TECHNICAL INFORMATION

73486

- Subject** ▶ Addition of Cap and Stopper, Change of Blade Case Complete, etc
- For Models** ▶ LS1013
- Country** ▶ Europe, Turkey, Cyprus, South Africa, China
- Description** ▶ Blade case complete and several parts have been changed/added because of modification on the mechanism for locking the blade case section at its upper dead point. See illustration below. Cap and Stopper have been added. See illustration in next page.

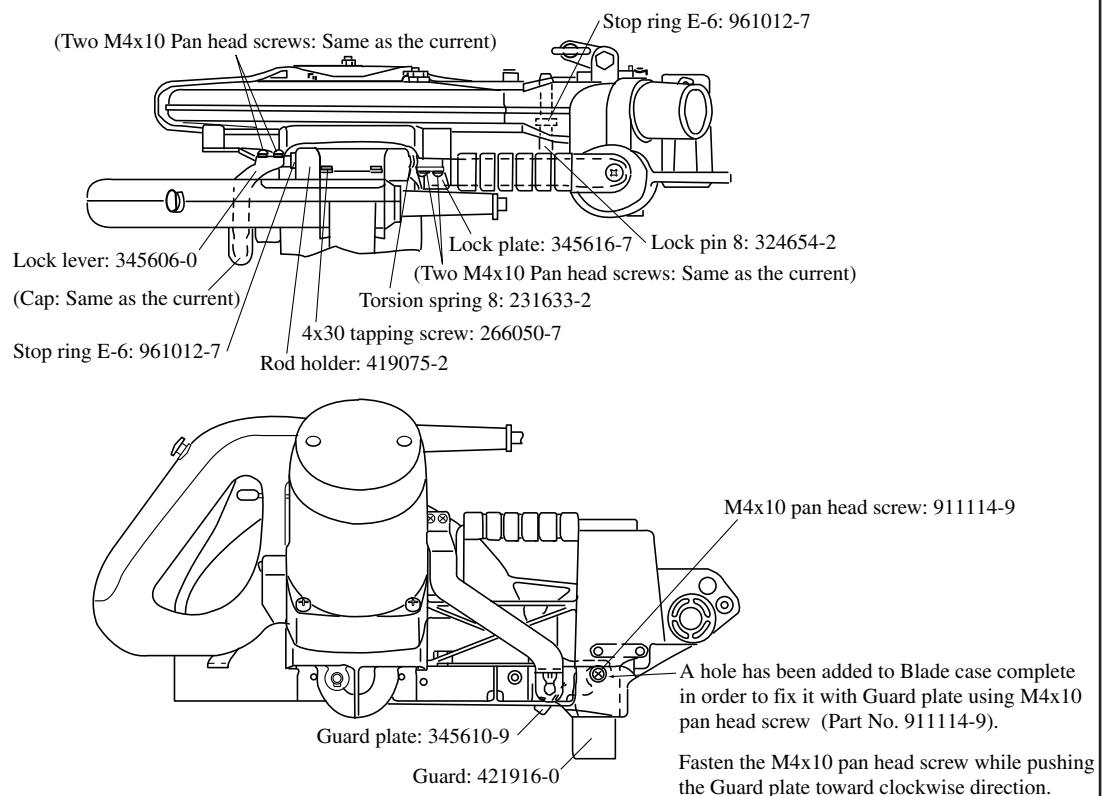
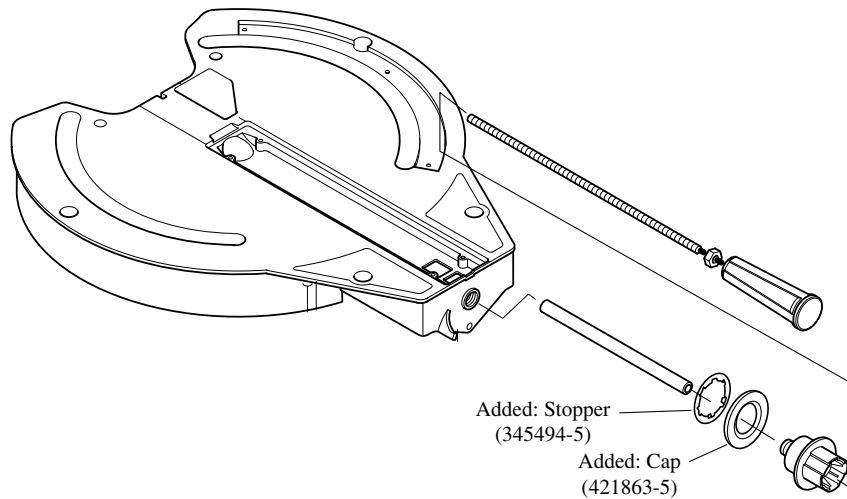
► Current

► New

Item No.	Current part		Q'ty	I/C	New part		Q'ty	Note
E27	Cap				Cap 421863-5		1	
E28	Stopper				Stopper 345494-5		1	
052	Blade Case Complete 151969-2		1	No	Blade Case Complete 154826-3		1	Interchangeable as a set
052	Blade Case Complete 154566-3		1	No	Blade Case Complete 154827-1		1	
904	Lever 344469-1		1	No	Lock Lever 345606-0		1	
900	Lock Plate 344855-6		1	No	Lock Plate 345616-7		1	
E25	Adjuster Plate		1		Adjuster Plate			
903	Rod 8 322984-5		1	No	Rod 8 324640-3		1	
E06	Compression Spring 7 231401-3		1	No	Torsion Spring 8 231633-2		1	
E26	Countersunk Head Screw M4x8		1		Countersunk Head Screw M4x8			
044	Tapping Screw 4x18 265995-6		6	No	Tapping Screw 4x30 266050-7		4	
E29	Tapping Screw 4x30				Tapping Screw 4x30 266050-7		2	
E30	Rod Holder				Rod Holder 419075-2		1	
E31	Stop Ring E-6				Stop Ring E-6 961012-7		1	
E32	Guard Plate				Guard Plate 345610-9		1	
E33	Guard				Guard 421916-0		1	
E34	Pan Head Screw M4x10				Pan Head Screw M4x10 911114-9		1

901	Lock Pin 8 322985-3		1	No	Lock Pin 8 324654-2		1	Interchangeable as a set
E31	Stop Ring E-6				Stop Ring E-6 961012-7		1
